AMENDMENTS TO THE DRAWINGS

Docket No.: 66967-0033

Application No. 10/562,662 Amendment dated July 8, 2009 Reply to Office Action of April 8, 2009

2. FR 1.373.752 to Spicer

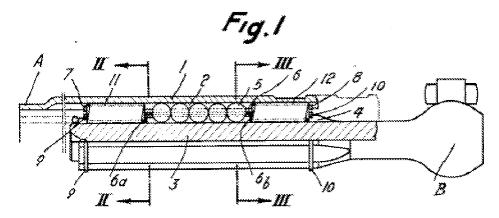
Turning specifically to Spicer, as shown below in reproduced FIG. 1, Spicer discloses spiral springs 11, 12 (see Attachment B, French – English translation of "resorts") that are disposed between the ball cage 6 and respective outer securing rings 7 and 8. The springs 11, 12 are arranged in the outer ball groove 2 and the inner ball groove 4, respectively.

A spring is clearly not the claimed abutment sleeve that is disposed on the profiled journal as claimed in independent claim 1. For this reason alone, claim 1 is patentable over Spicer.

Moreover, claim 1 also positively recites that the claimed abutment sleeve abuts the profiled journal, or a component connected thereto, with an axial distance from the ball groove run-outs in a region of the second portion of the profiled journal. This feature is also not shown in Spicer. Instead, referring back to FIG. 1 of Spicer reproduced above, the securing ring 10 against which the spring 12 axially stops, is arranged within the axial region of the ball groove 4 of the profiled journal 3. Thus, Spicer fails to teach, suggest or disclose an abutment sleeve which is arranged on the profiled journal and which is axially supported in a region of the second portion of the profiled journal with an axial distance to the ball groove run-outs. If anything, Spicer teaches away from the claimed construction in that it teaches a securing ring 10 arranged in the region of the ball grooves 4. For at least this second reason, claim 1 is patentable over Spicer. Accordingly, withdrawal of the rejection is respectfully requested.
